Re: Indian Point Unit No. 2
Docket No. 50-247

RESPONSE TO NRC REQUEST
FOR ADDITIONAL INFORMATION ON NUREG-0737 ITEMS:

II.F.1.4 CONTAINMENT PRESSURE MONITOR
II.F.1.5 CONTAINMENT WATER LEVEL
II.F.1.6 HYDROGEN MONITOR

FIGURE 2

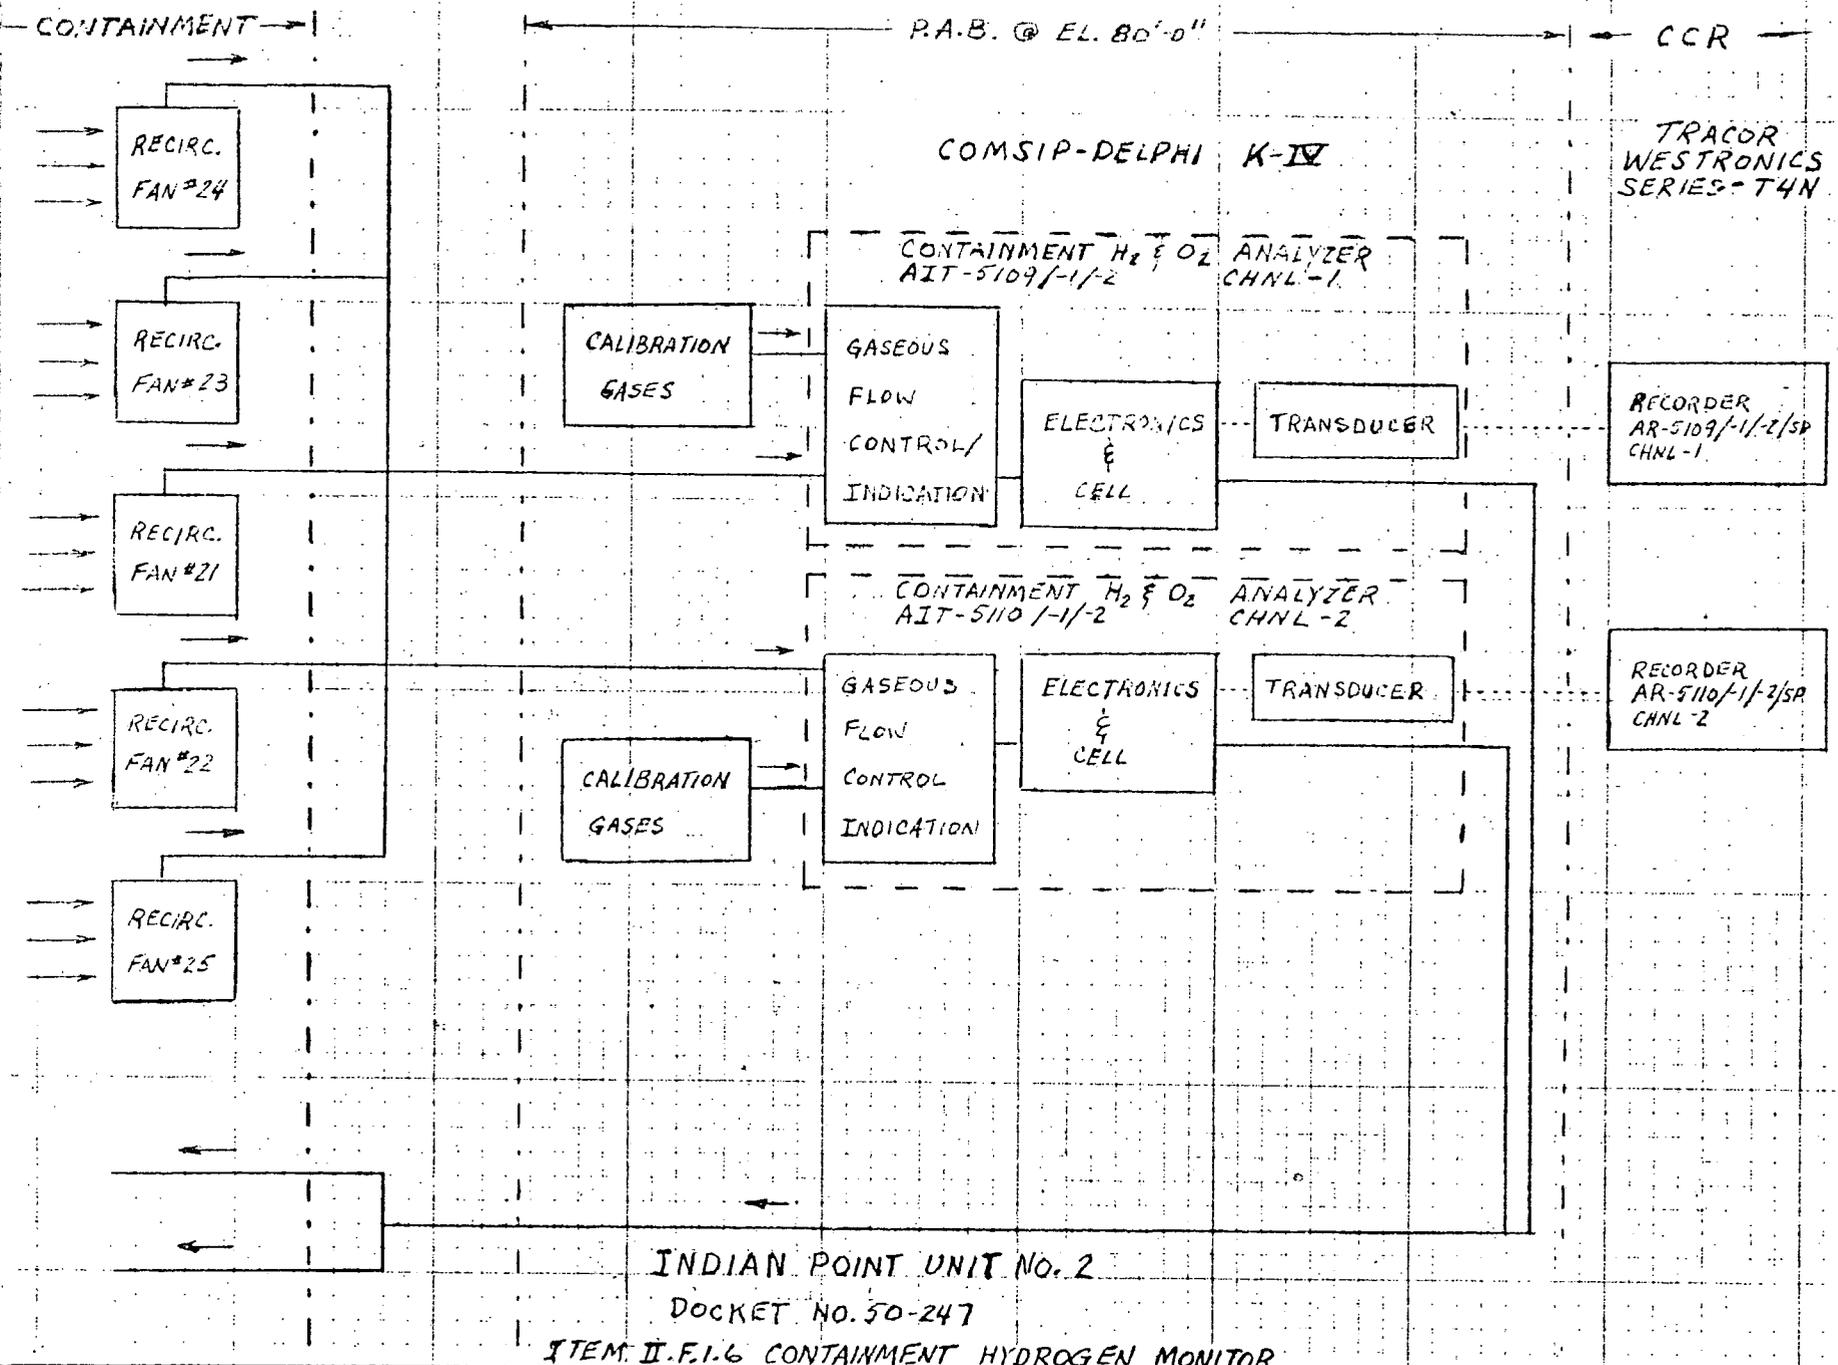
- a) Provide a block diagram of the configuration of modules that make up your WLMS. Provide an explanation of any details in the block diagram that might be necessary for an understanding of your WLMS accuracy.
- b) For each module provide a list of all parameters which describe the overall uncertainty in the transfer function of that module.
- c) Combine parameters in 3b to get an overall system uncertainty. If you have both strip chart recorder and indicator output, give the overall system uncertainty for both systems. If you have systems spanning different ranges, give the overall system uncertainty for each system.

- a) The water level monitoring system (WLMS) is shown in Figure 2 and consists of monitors as described in Con Edison letters dated October 17, 1979 and May 12, 1981. However, the installation of the Reactor Cavity Pit water level monitor described in our May 12, 1981 letter is not intended to satisfy NUREG-0737 Item II.F.1 Attach. (5) criteria but is for monitoring inleakage during normal plant operation as a result of the October, 1980 flooding incident. This water level monitor represents an enhancement of overall accident containment water level monitoring capability. The level transmitter in the reactor cavity pit was changed during the 1982 outage. This transmitter was replaced with a Barton "Lot 7" unit with a span of 27 ft (Elevation 19'-9" to 46'-9"). This change allows the transmitter to be above the 46' 00" el. of the containment sump curb.

- b) Differential Pressure Level Monitors for:

Containment Sump	(LT 3300)	Span 216"
Recirculation Sump	(LT 3301)	Span 216"

FIGURE 3A

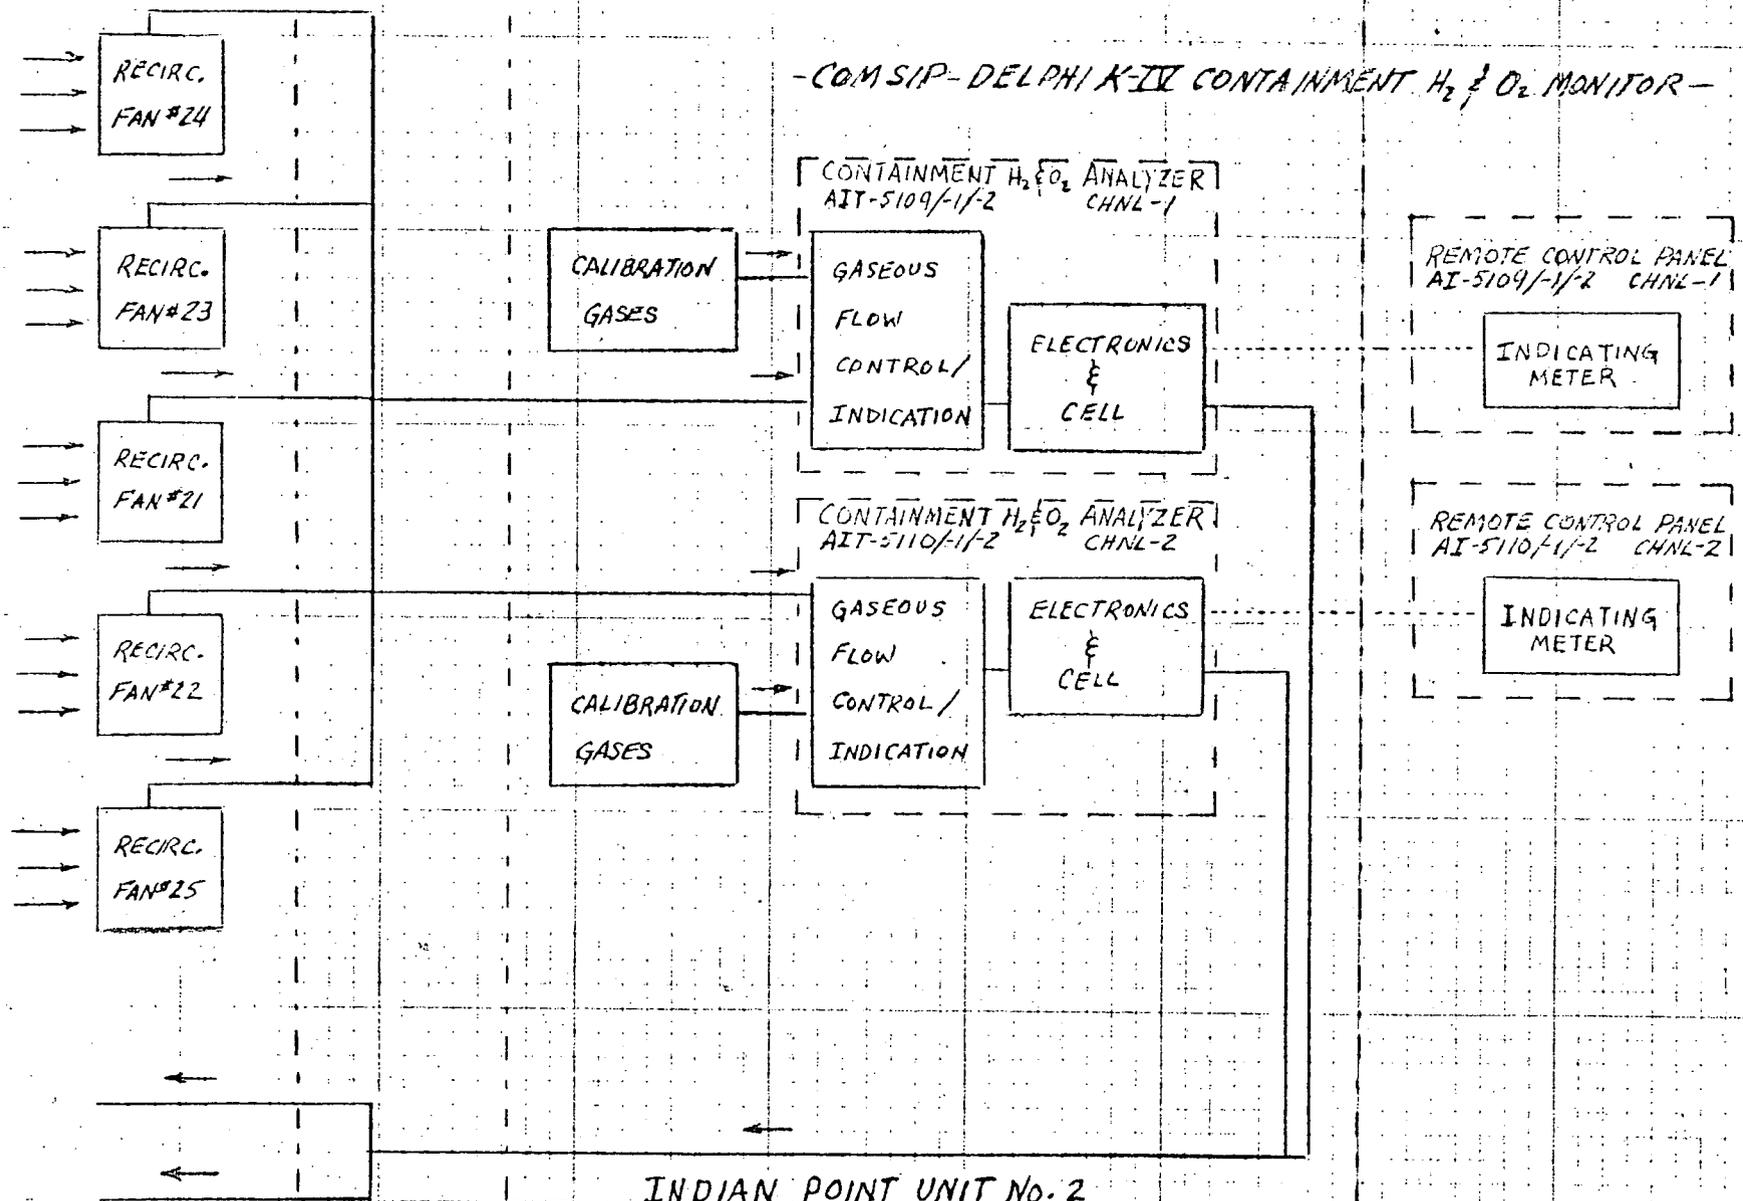
- a) Provide a block diagram of the configuration of modules that make up your HMS. Provide an explanation of any details in the block diagram that might be necessary for an understanding of your HMS accuracy. If you have different types of HMS's give this information for each type.
- b) For each module provide a list of all parameters which describe the overall uncertainty in the transfer function of that module.

- a) Block diagrams of the installed HMS are shown in Figures 3a and 3b. Two Comsip-Delphi K-IV Hydrogen and Oxygen Monitors, each consisting of an analyzer panel and a remote panel, are installed with separate sample lines from containment. The remote panel with its indicating meter is located in the PAB-Motor Control Center (Case #2). In addition, Tracor-Westronics, Series T4N recorders are installed for the H₂ and O₂ indicator/recorder in the CCR (Case #1). The accuracy data provided below are based on vendor supplied information for these models.
- b) Comsip-Delphi K-IV Post-LOCA Containment Hydrogen and Oxygen Monitoring System Characteristics:
